Comment On: NRC-2012-0042-0002
Draft Regulatory Guide DG-1262 - Testing for Postquench Ductility

Fuel Reliability Program_FRP 2014-02

August 20, 2014

Subject: RIN 3150-AH42, "Performance-Based Emergency Core Cooling Systems Cladding Acceptance Criteria"

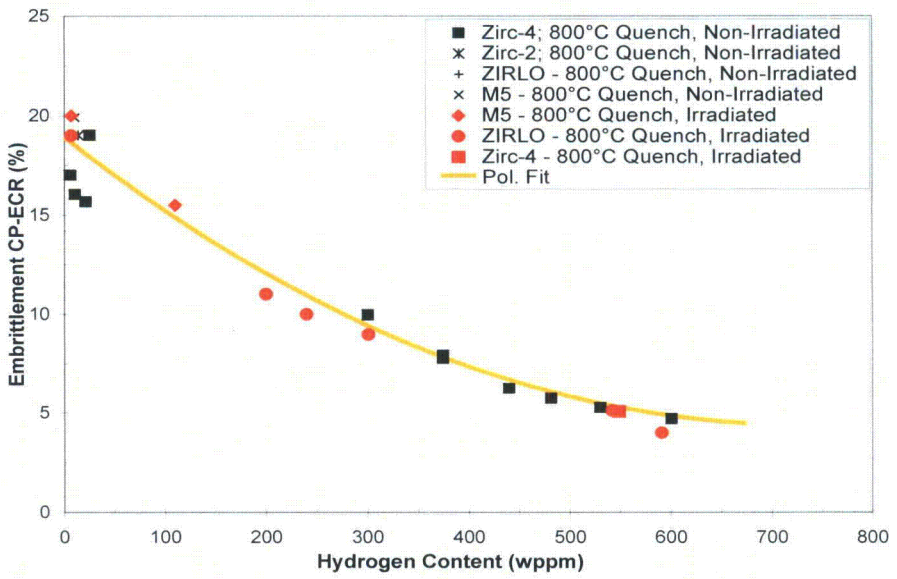
Comment	Use of test specimens with hydrogen pre-charge can provide a suitable surrogate for irradiated materials, obviating the need for the hydrogen concentration to be within 50 ppm of irradiated data. Moreover, if testing of irradiated cladding for significant compositional changes is elected, testing to compare hydrogen pre-charge data can be reduced to one irradiation exposure near end-of-life condition.
Rationale	The NRC test results plotted below showed no difference in behavior between irradiated and non-irradiated materials for multiple alloys made by different fuel vendors. The test data support the use of hydrogen pre-charge as a surrogate for irradiation.

Numerous mechanical tests have shown irradiation damages are annealed out at LOCA temperatures (> 700°C). Irradiation will have a small impact on the chemical makeup of zirconium based alloys, which are typically greater than 97% zirconium. A very small fraction of the alloying elements may transmutate into other elements. Testing of different irradiated alloys in the ANL program showed transmutation of the common alloying elements in commercial service today to have no effect on the cladding ductility degradation and therefore additional testing of irradiated cladding of variations of these alloys is not needed. If the alloy composition changes significantly, such as the addition of new alloying elements, the transmutation effect could still be captured by the addition of expected transmutation products (non radioactive isotope) into the alloy melt for evaluation.
